RE: Minor Permit Revision To Include a Selenium Treatment Building
Permit to Mine 603, Highland Uranium Project

FIGURE 1(2)

4. Brief description of permit revision: Selenium removal plant

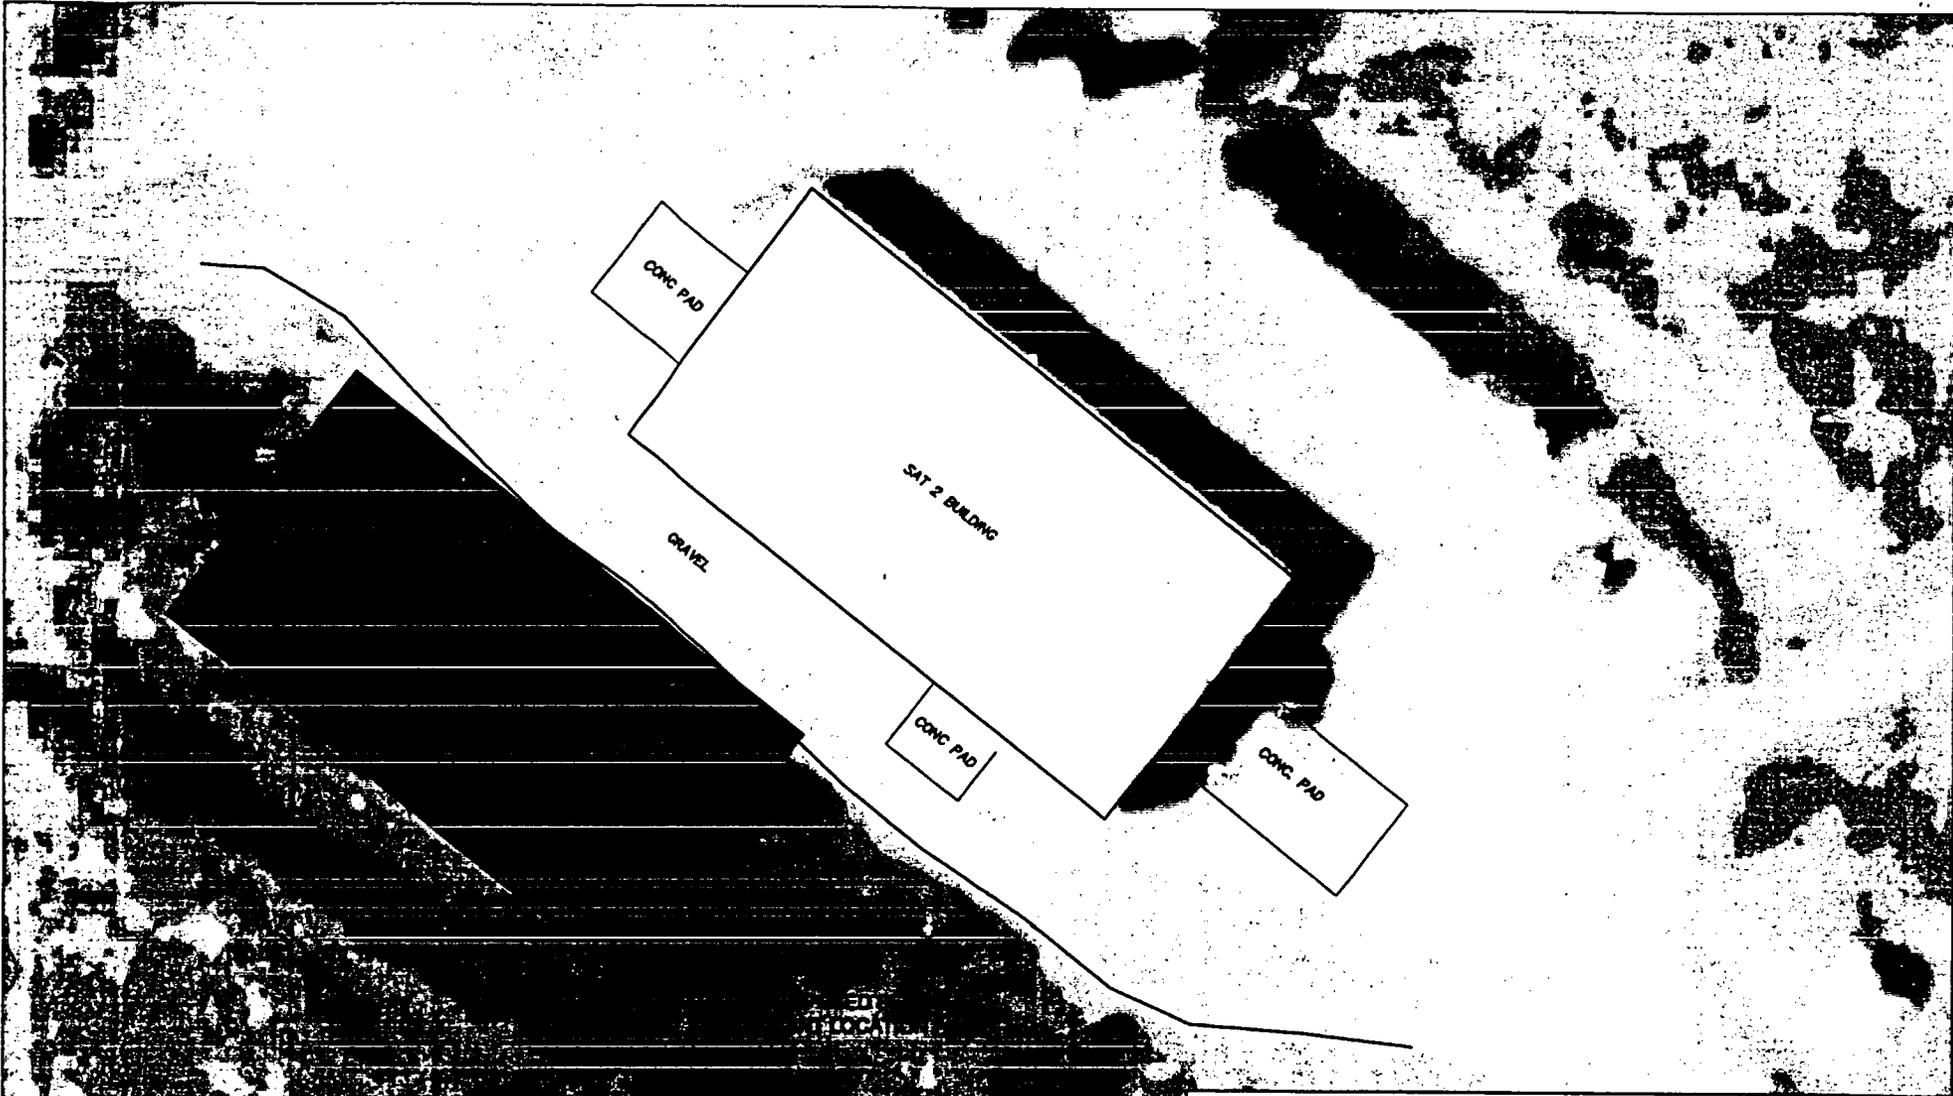
The selenium treatment facility will be located approximately 30 feet southwest of Satellite No. 2 and will be 80 feet wide by 150 feet long. The facility will be connected to Satellite No. 2 through buried pipelines and will house the selenium treatment circuit. After selenium treatment the water will be returned to Satellite No. 2 for wastewater disposal.
